QUALITY ASSURANCE -- NON-CONFORMANCE REPORT

Location: Changxing Island, Shanghai, P.R. China**Report No:** NCR-000836**Prime Contractor:** American Bridge/Fluor Enterprises, a JV**Date:** 09-Sep-2010**Submitting Contractor:** Zhenhua Port Machinery Company, Ltd (ZPMC), Changxing Island**NCR #:** ZPMC-0798**Type of problem:**

Reference Description: QA found a missed UT indication after ZPMC had tested and accepted a side panel weld in Segment 11EE

To: AMERICAN BRIDGE/FLUOR, A JV **Date:** 10-Sep-2010
 375 BURMA ROAD
 OAKLAND CA 95607 **Contract No:** 04-0120F4
 04-SF-80-13.2 / 13.9
Dear: Mr. Charles Kanapicki **Job Name:** SAS Superstructure
Attention: Mr. Thomas Nilsson Project/Fabrication Manager **Document No:** 05.03.06-000792
Subject: NCR No. ZPMC-0798

Description of Non-Conformance:

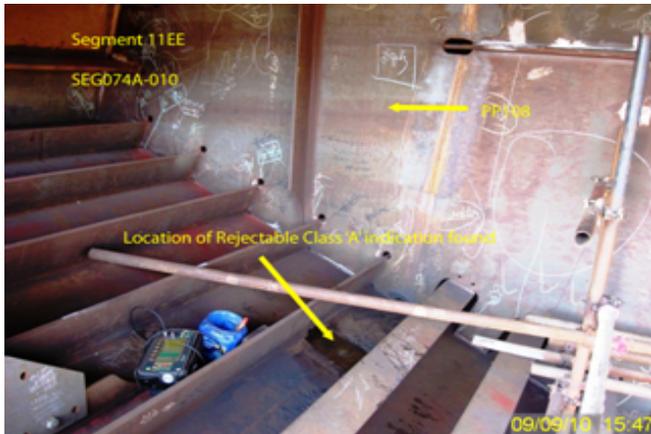
During the Quality Assurance (QA) Ultrasonic Testing (UT) review of weld located on Segment 11EE, this QA Inspector discovered the following issue:

- One (1) Class "A" indication measuring approximately 20 mm in length.
- The dB rating is +9.
- The weld is identified as SEG074A-010.
- The weld is a Complete Joint Penetration (CJP) butt weld joining Side plate SP330A (PL985A) to Side plate SP718A (PL1432 SPCM).
- The Thickness of the Side plate is 18mm.
- The "Y" location is approximately 800mm away from Panel Point 108 towards East side.
- The indication is clearly marked by QA on/near the weld.
- OBG Segment 11EE is located in Repair yard (West side of Bay 14).
- This weld joint is designated as Seismic performance critical weld member (SPCM).

The Notice of Witness Inspection Number (NWIT) is 006616. The indication is located inside the area that has been previously tested and accepted by ZPMC Quality Control (QC) personnel. As per the contract documents, ZPMC's QC personnel are required to perform 100% UT inspection of this weld.

AWS D1.5-2002, Section 6, Table 6.3. Specifies a class A indication as having a db's rating of +10 and lower for weld thicknesses 8mm through 20mm.

Reference Resolution: ZPMC has repaired the missed indications and is providing the WWR used at the time to repair the weld and the UT report performed after to show that the weld is acceptable.

ZPMC has repaired the missed indications and is providing the WWR used at the time to repair the weld and the UT report performed after to show that the weld is acceptable. To prevent future occurrences ZPCM has written an internal NCR and the inspector who missed the indications has been identified and his performance will be monitored to ensure that he does not continue a pattern of missed indications. Based on this ZPMC requests closure of this NCR.

The proposed resolution is acceptable. This NCR is considered closed.

焊缝编号为： SEG074A-010

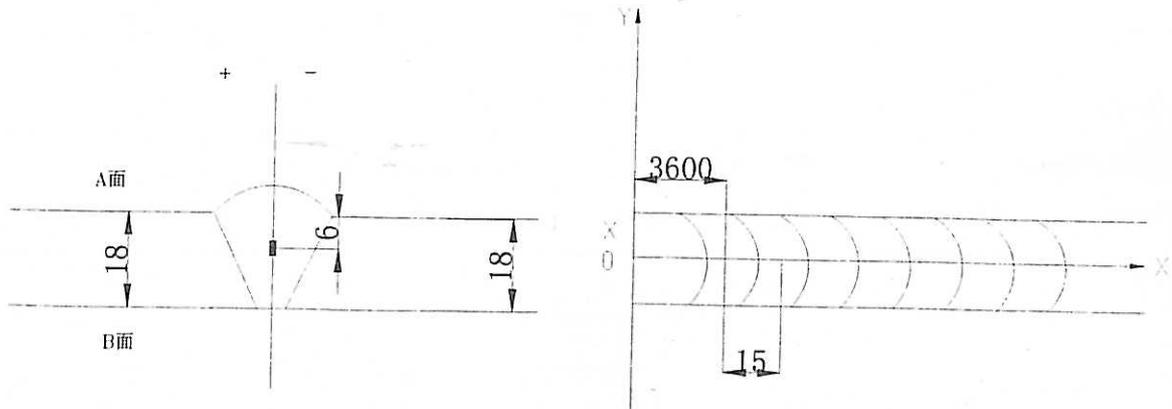
(Description of welding discontinuity): Rejected indication found by ultrasonic inspection is less than the maximum allowance aggregate length.

1. 从缺陷距离端面较近一侧 ($D \leq 0.65T$, D 为缺陷深度, T 为板厚) 采用碳刨或打磨的方法去除焊缝缺陷;
2. 参照返修焊接工艺规程 (WPS) 准备正确的接头型式, 预热和焊接;
3. 将修补区域打磨到与母材或邻近焊缝平齐;
4. 根据批准的车间图纸检查焊缝.

1. Gouge or grind from nearer side from metal edge ($D \leq 0.65T$, "D" is depth of defects, "T" is thickness of metal) to remove all defects;
2. Follow repair WPS for joint preparation, preheat, and weld deposit;
3. Grind the repaired area flush with base metal or the adjacent weld;
4. Check the welds according to the working drawings.

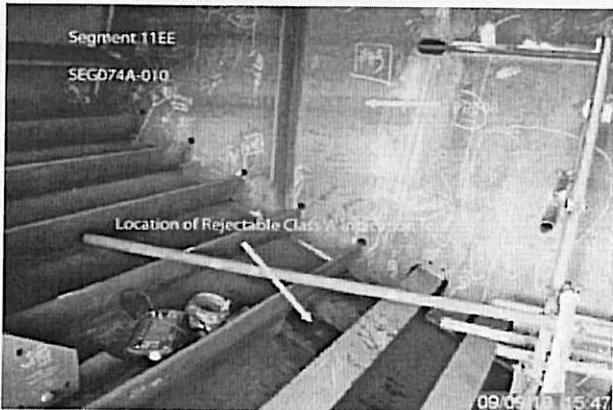
During the Quality Assurance (QA) Ultrasonic Testing (UT) review of weld located on Segment 11EE, this QA Inspector discovered the following issue:

- One (1) Class "A" indication measuring approximately 20 mm in length.
- The dB rating is +9.
- The weld is identified as SEG074A-010.
- The weld is a Complete Joint Penetration (CJP) butt weld joining Side plate SP330A (PL985A) to Side plate SP718A (PL1432 SPCM).
- The Thickness of the Side plate is 18mm.
- The "Y" location is approximately 800mm away from Panel Point 108 towards East side.
- The indication is clearly marked by QA on/near the weld.
- OBG Segment 11EE is located in Repair yard (West side of Bay 14).
- This weld joint is designated as Seismic performance critical weld member (SPCM).

The Notice of Witness Inspection Number (NWIT) is 006616. The indication is located inside the area that has been previously tested and accepted by ZPMC Quality Control (QC) personnel. As per the contract documents, ZPMC's QC personnel are required to perform 100% UT inspection of this weld.

AWS D1.5-2002, Section 6, Table 6.3. Specifies a class A indication as having a dbS rating of +10 and lower for weld thicknesses 8mm through 20mm.

Contractor proposes to repair the missed indications, and provide the Welding Repair Report. UT will be performed to show the weld is acceptable. Contractor will identify the inspector, and issue an NCR to him. Performance will be monitored to ensure he will not miss the indications continuously.

Contractor repaired the indications with WWR document support. UT was performed after repair. UT report showed the weld is acceptable. Contractor also identified the inspector, and issued an internal NCR to him. The inspector's performance is monitored by Contractor.
